**LFPCNUSA2022-002**

**Product Change Notification for Littelfuse**

MOSFET DISCRETE, IGBT DISCRETE, Thyristor and Diodes in TO-247 package add new manufacturing location

## 1. POD – Package Outline Dimension

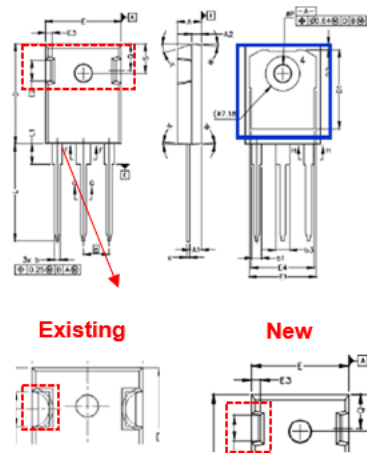
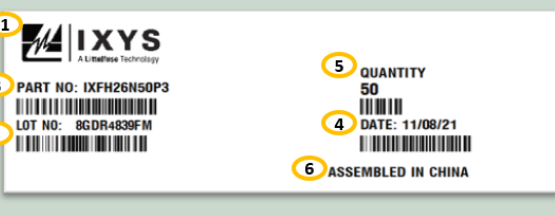
**DESCRIPTION OF CHANGE:** As a part of Littelfuse endeavors to improve the manufacturing footprint, it has been decided to introduce a new TO-247 backend manufacturing ASEWH in China for the affected part numbers listed below. With this additional capacity to support the upcoming customer demands.

**Form, fit, function changes:** No change in the silicon dice used. We would like to notify you on the differences between the existing manufacture and new manufacture.

1. POD – Package Outline Dimension
2. Package Marking
3. BOM
4. Label

| Items | Existing POD |       | New POD |       | Remark          |
|-------|--------------|-------|---------|-------|-----------------|
| A     | 4.70         | 5.30  | 4.83    | 5.21  |                 |
| E2    | 4.31         | 5.48  | 3.68    | 5.10  | Body Notch Area |
| L1    | -            | 4.49  | 4.10    | 4.40  |                 |
| S     | 6.14BSC      |       | 6.04    | 6.30  |                 |
| D1    | 13.07        | -     | 16.25   | 17.65 |                 |
| E1    | 13.45        | -     | 12.38   | 13.43 |                 |
